Re: J. W. Brendle Drain, Wexley Chase Arm

Re: JW Brendle Drain: Wexley Chase Arm

WEXLEY CHASE SUBDIVISION

SUB-SURFACE DRAIN PLAN
WEXLEY CHASE
HAMILTON COUNTY
CARMEL, INDIANA

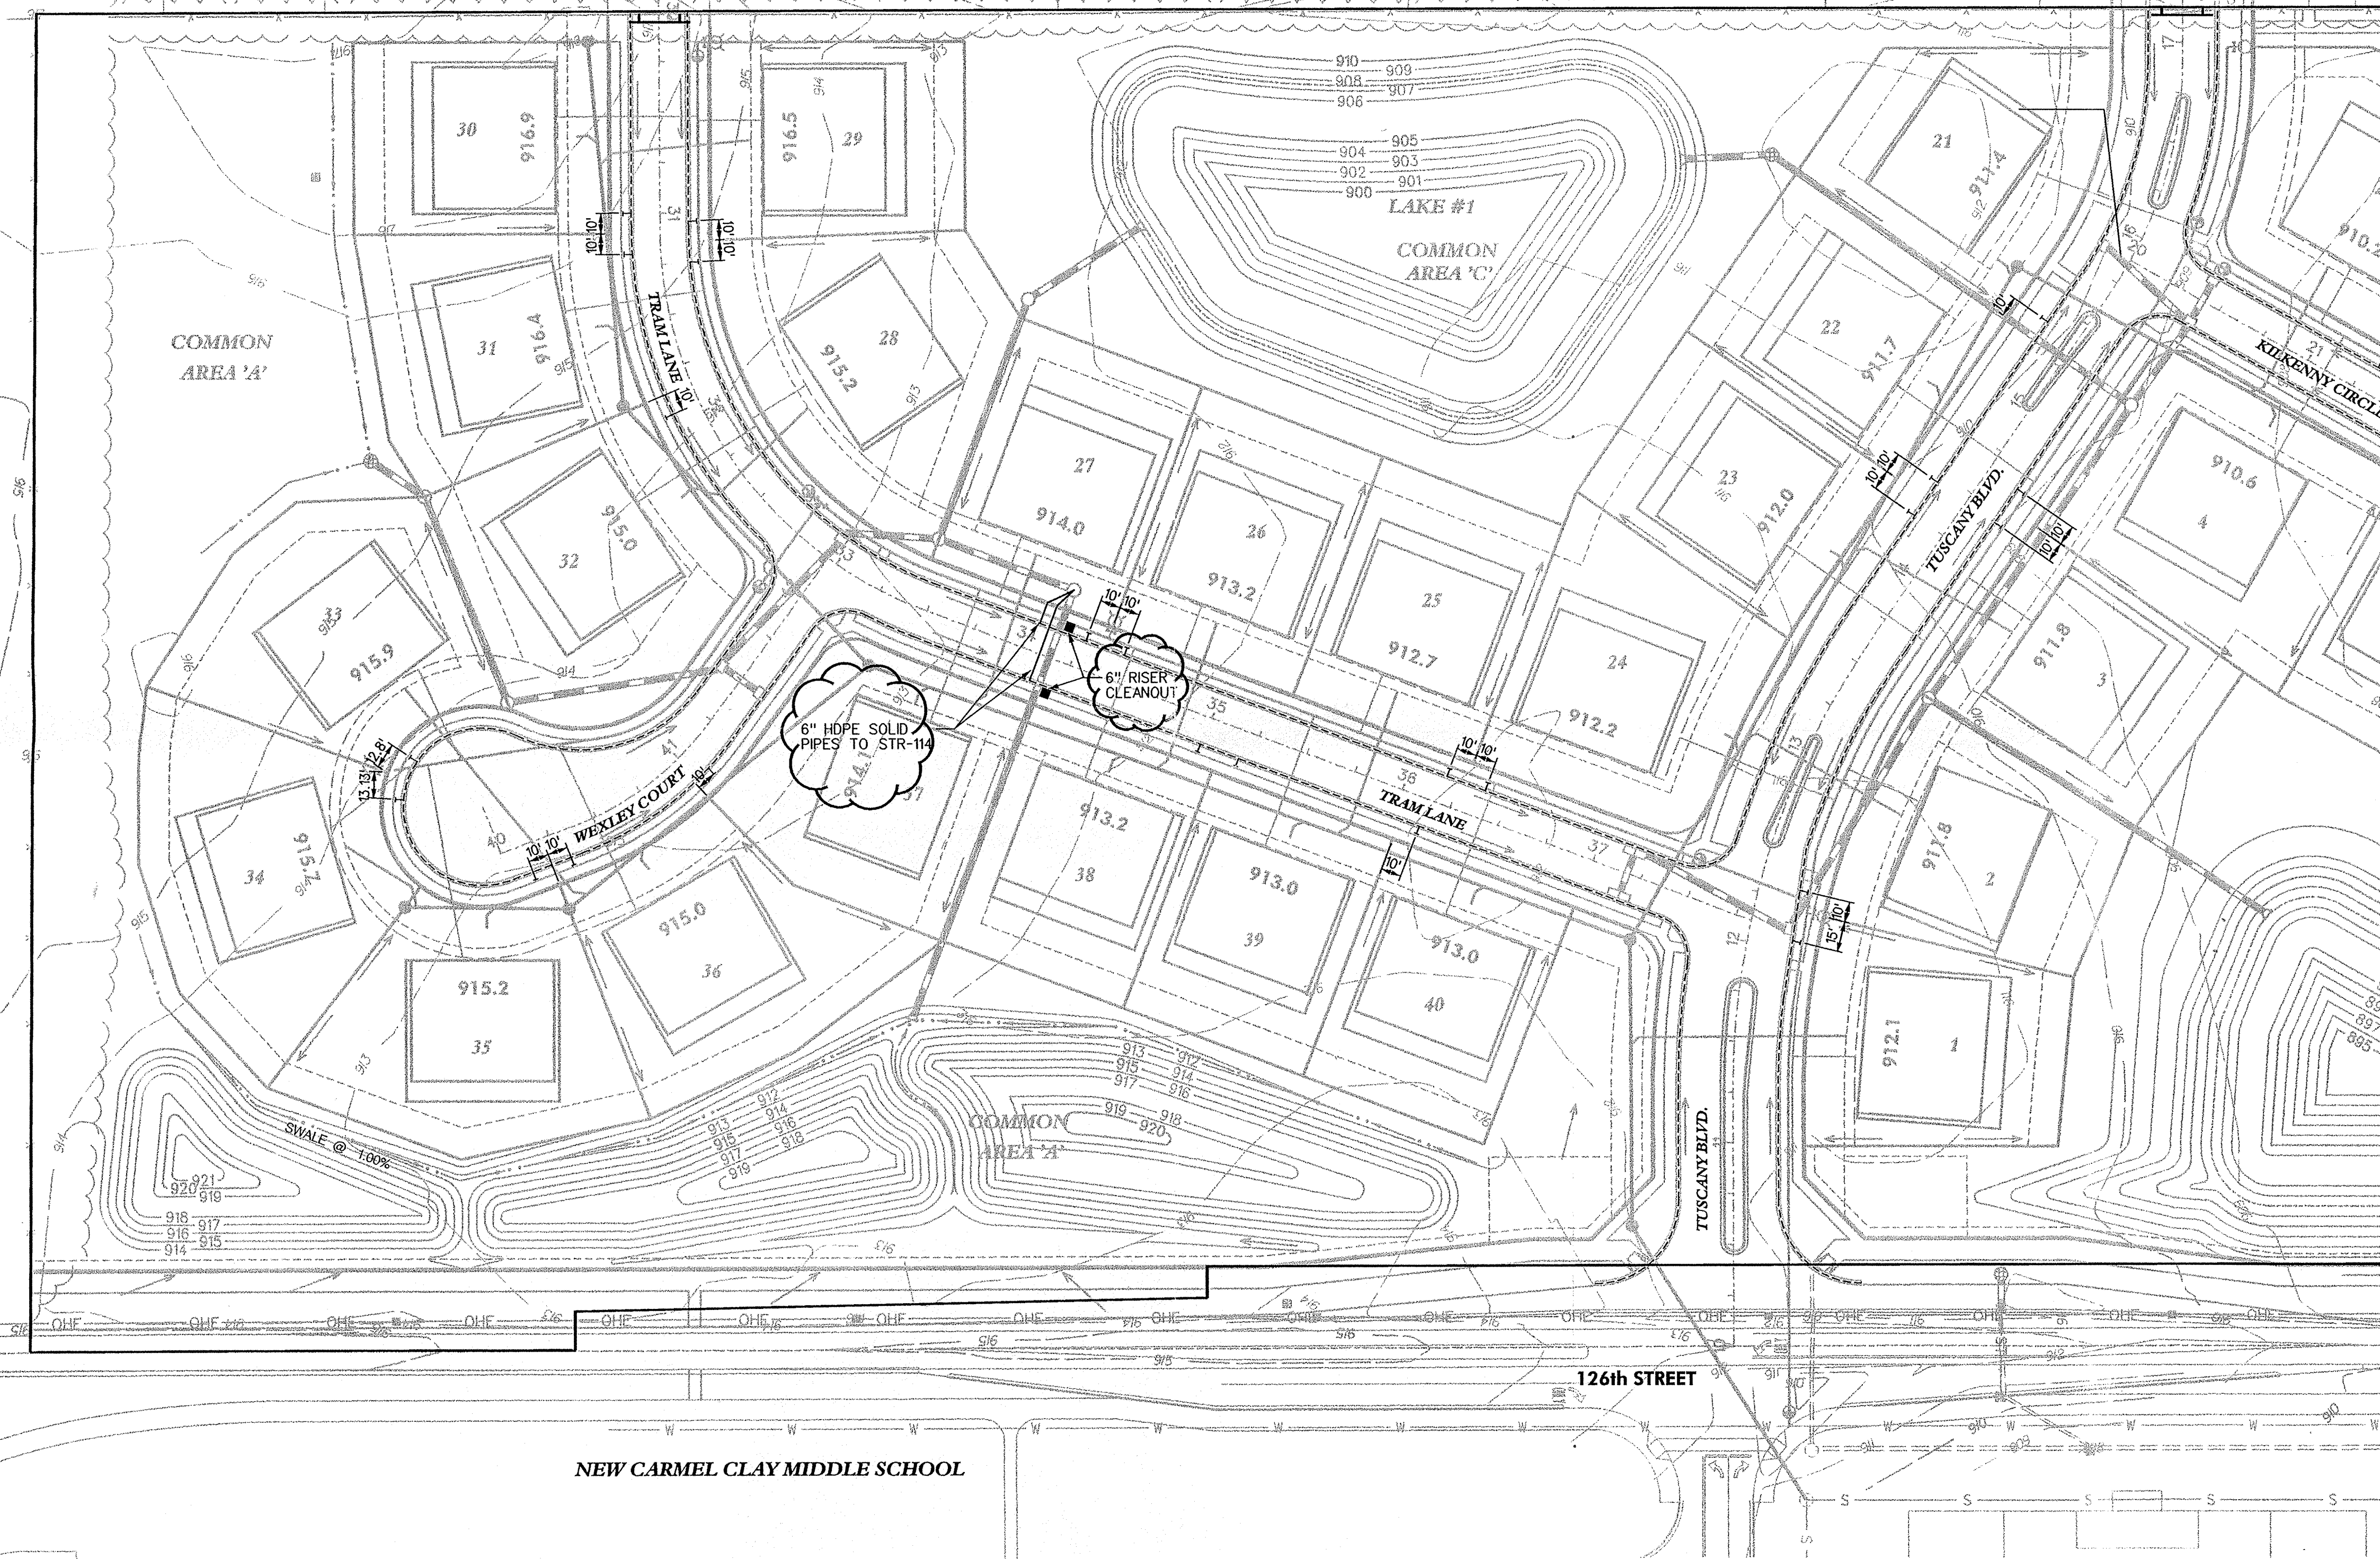
6" SUB SURFACE DRAIN ON THE WEST SIDE OF THE 12" RCP TURNS NORTH @ 34+10 AND TIES INTO STRUCTURE #114; 6" HDPE SOLID PIPE WAS USED AND BOTH SIDES OF STREET SSD WAS KEPT INDEPENDENT OF EACH OTHER.

6" SUBSURFACE DRAIN ON THE EAST SIDE OF THE 12" RCP TURNS TOWARD THE CURBS ON EACH SIDE OF THE STREET @ 34+40 AND A 6" RISER CLEANOUT WAS INSTALLED BEHIND THE CURB ON EACH SIDE OF THE STREET. CLEANOUTS WERE INSTALLED PER HAMILTON COUNTY SPECIFICATIONS.

STRUCTURE #114 WAS CHANGED TO A 48" ROUND STRUCTURE TO ACCOMMODATE THE SSD CHANGE.
